SUBJECT: S.P. 6212-167 (T.H. 36 Over Keller Lake) St Paul, MN
Bridge No. 62037 Plan revisions for Abutments and Piers

I've enclosed the revised Plan Sheet Nos. 2R, 10R, 11R, 12R, 13R, 21R, 22R, 23R, 24R, 29R, 30R, 31R, 31AR, 32R, 33R, and 33AR. The details were updated in order to ensure proper fabrication. Please remove and discard Sheet Nos. 2, 10, 11, 12, 13, 21, 22, 23, 24, 29, 30, 31, 32 and 33 in your original plan set and insert the enclosed new sheets. Thank you.

SUBJECT: S.P. 6212-167 (T.H. 36 Over Keller Lake) St Paul, MN
Bridge No. 62037 Plan revisions for Inverted Tee Beams and Deck
Reinforcement

TITLE:
**PIER 1 AND PIER 2 REINFORCEMENT
 STAGE 1 CONSTRUCTION**

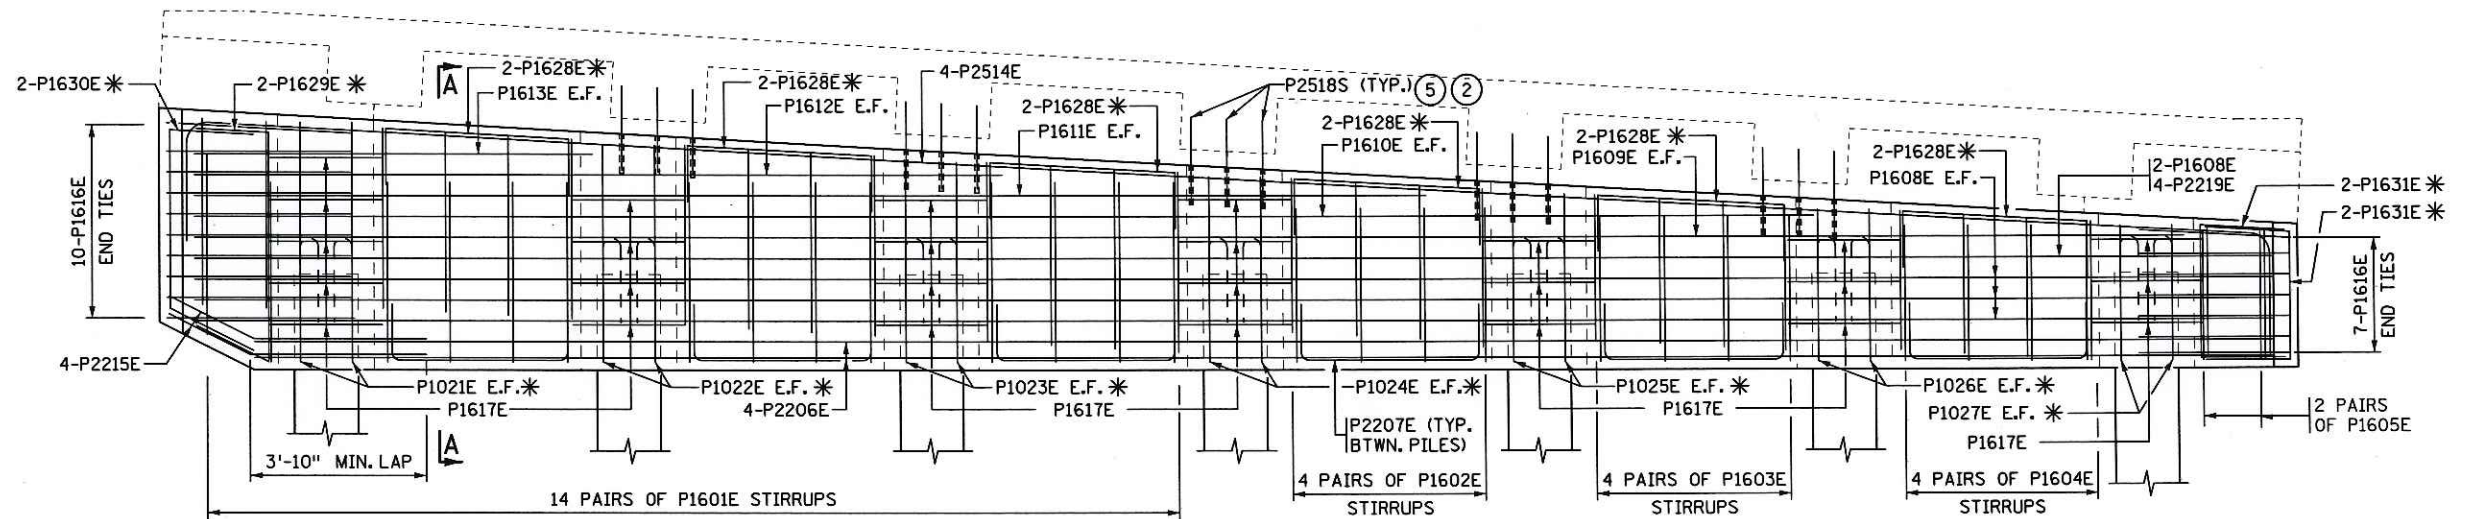
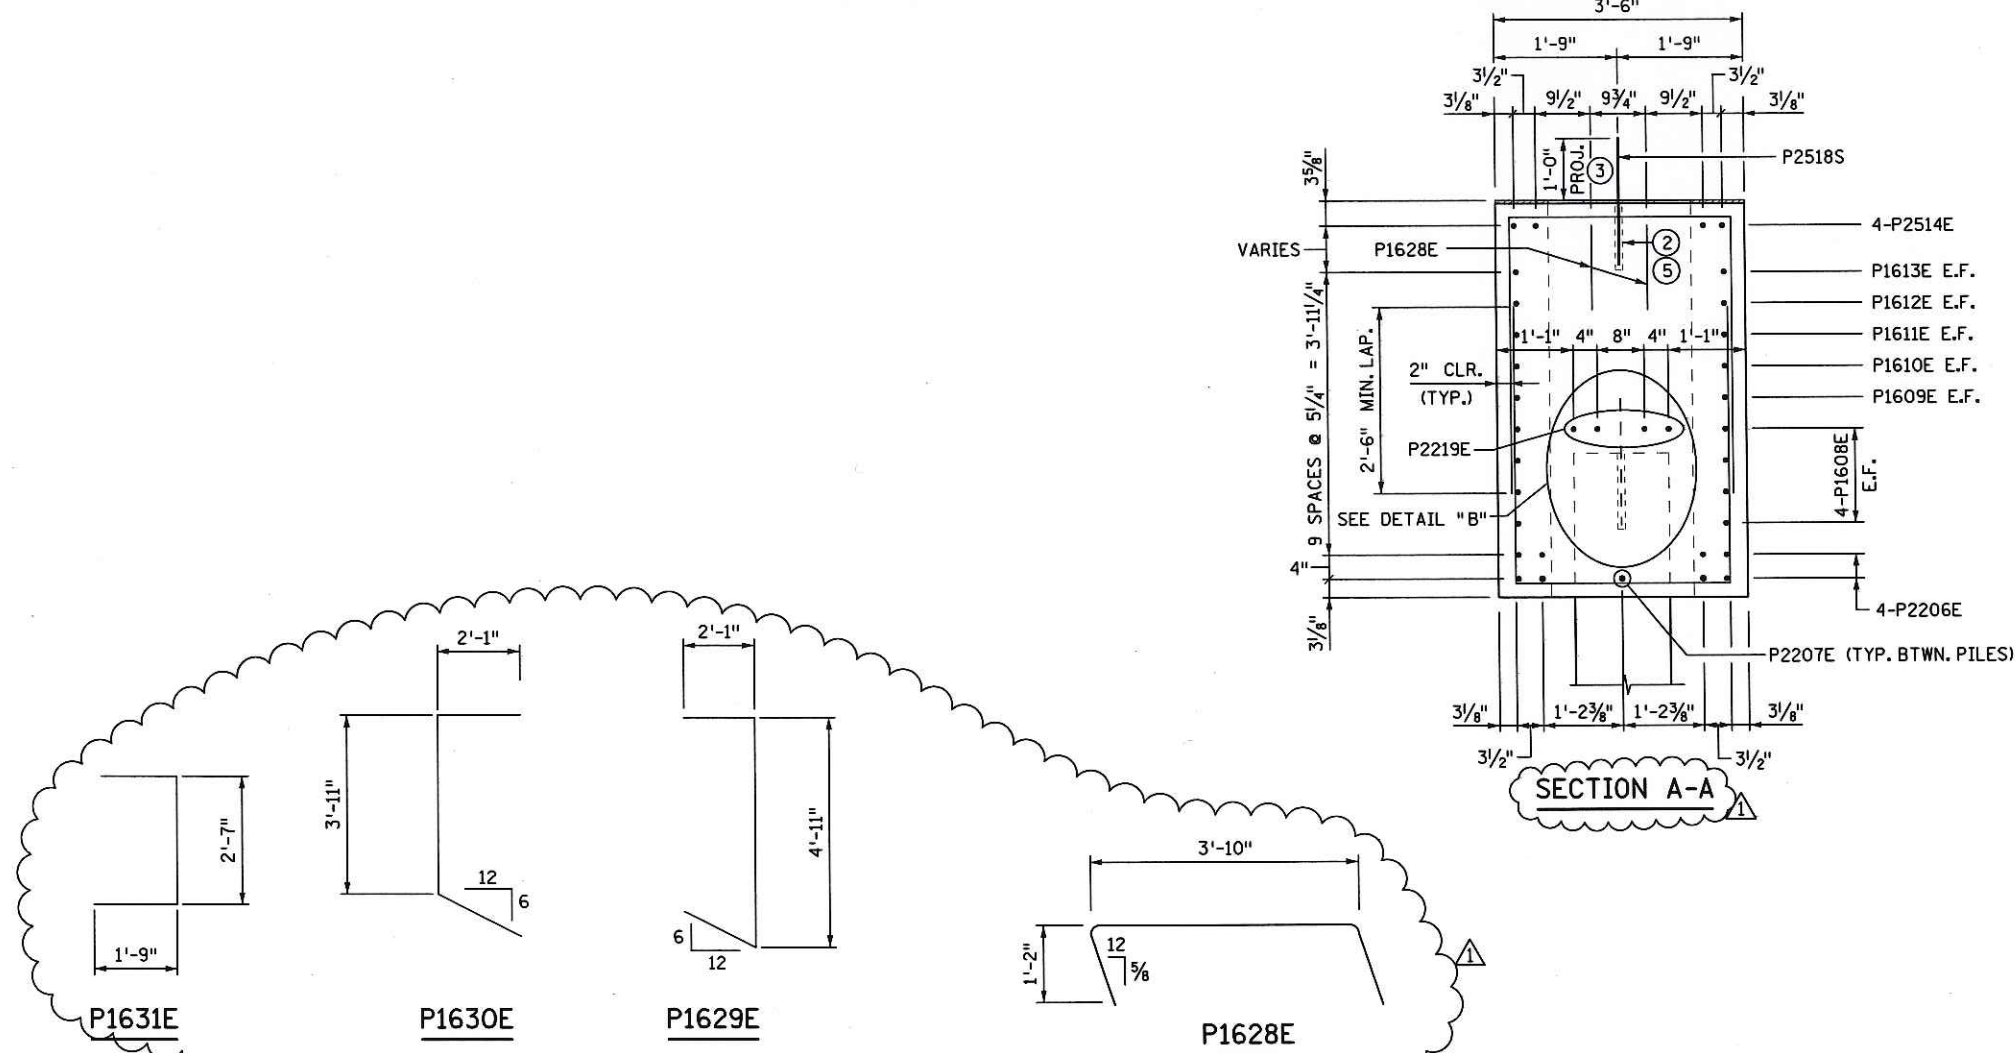
NOTES:
 * DENOTES ADDED REINFORCING.
 SEE SHEET NO. 31AR FOR KEYNOTES & SECTION A-A.
 E.F. DENOTES EACH FACE

REVISION		
DATE	DESCRIPTION	APPROVED BY
5-21-2013	ADDED REINFORCING FOR EASE OF FABRICATION	AMS
